PPIRM-77H

Answers

Re: FCC ID PPIRM-77H

Applicant: Nokia GmbH
Correspondence Reference Number: 29546

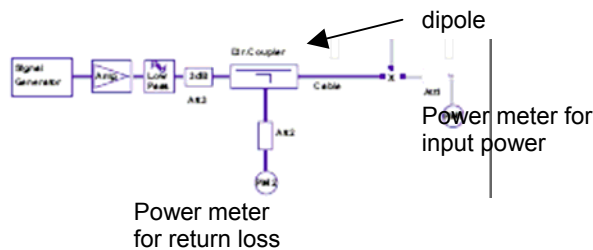
- The other E-field measurement result given in the same table (163.8) should be correspondingly: $(162.8+163.8)/2 = 163.3$.
- 7) Please provide full setup details for the validation measurement.

- The input signal was an unmodulated continuous wave, and average input power = 100mW after adjustment for return loss. The proper measurement of the 1cm probe to dipole separation, which is measured from the top surface of the dipole to the calibration reference point of the sensor, defined by the probe manufacturer. A dipole antenna meeting the requirements in PC63.19 was placed in the position normally occupied by the WD. The length of the dipole was scanned with both E-field and H-field probes and the maximum values for each were recorded.

Setup for desired output power to dipole:
